Access Compliance Report Public Rights-of-Way (Curb Ramps)

Main Street: AIROSO_ST Cross Street: BARACA_DR Location: SW

ADA ID: RPRK211201144137 Ramp Type: Type 3 - Combination 1 Initial Pass/Fail: Fail Overall Compliance: No Severity Score: 30

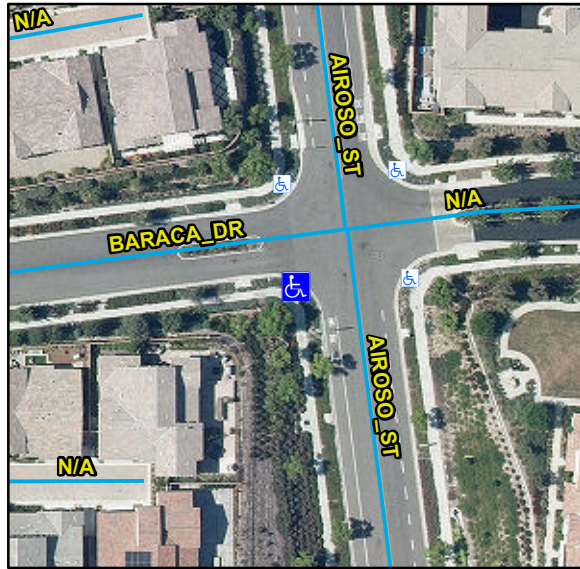
R304.3.2, STD 1115

Compliance	Description	Data	Compliance	Description	Data
N/A	Ramp Length LT (in)	126	N/A	Ramp Length RT (in)	142
Yes	Ramp Width LT (in)	60	Yes	Ramp Width RT (in)	57
No	Ramp Run Slope LT (%)	15.7	No	Ramp Run Slope RT (%)	11.5
Yes	Ramp Cross Slope LT (%)	1.1	Yes	Ramp Cross Slope RT (%)	0.7
N/A	Ramp Length (in)	150	N/A	Flare Type LT	
Yes	Ramp Width (in)	60			N/A
Yes	Ramp Run Slope (%)	5.9	N/A	Flare Slope LT (%)	N/A
Yes	Ramp Cross Slope (%)	3.3	N/A	Flare Traversable LT	N/A
N/A	Landing Present	N/A	N/A	Flare Type RT	
N/A	Landing Length (in)	N/A			N/A
N/A	Landing Width (in)	N/A	N/A	Flare Slope RT (%)	N/A
N/A	Landing Run Slope (%)	N/A	N/A	Flare Traversable RT	N/A
N/A	Landing Cross Slope (%)	N/A	N/A	DWS Provided	N/A
N/A	Landing Movement Obstructed?	N/A	N/A	DWS Contrast	N/A
	Landing Movement Type	N/A	N/A	DWS Length (in)	N/A
N/A	Landing Shared	N/A	N/A	DWS Full Width	N/A
N/A	Clear Space	Yes		DWS Offset Type	N/A
N/A	Clear Space To Crosswalk (in)	N/A	N/A	DWS Offset Left (in)	N/A

Remove & Replace Curb Ramp With Two New Directional Ramps or Equivalent.
